MARITIME SAFETY COMMITTEE
99th session
Agenda item 20

MSC 99/20/9
13 February 2018
Original: ENGLISH

Proposal for a new output concerning amendments to the Code of Safety for Diving Systems and resolution A.692(17)

Submitted by the Russian Federation, Vanuatu, IMCA and IOGP

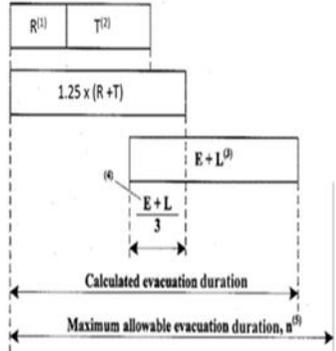
71	Time to evacuation		<p>New text proposal.</p> <p>To date and based upon earlier vessel requirements the "target" for evacuation was based upon Cargo ship requirements (15 m) with a bit of stretch, however, IMO has done significant work regarding how to handle longer time frames for evacuation primarily with passenger vessels and the required stability and fire levels.</p> <p>Passenger vessels now have allowable evacuation times of up to 80 min, based upon fire safety and stability.</p> <p>There is no consideration of recovery speed allowable difference in split level, blow down and vent.</p> <p>It is our view that the approach to passenger ships could be a suitable alternative where stages are identified and tested leading to an overall evacuation time. (Note letters would be changed for a dive evacuation but it is a good graphical representation).</p>
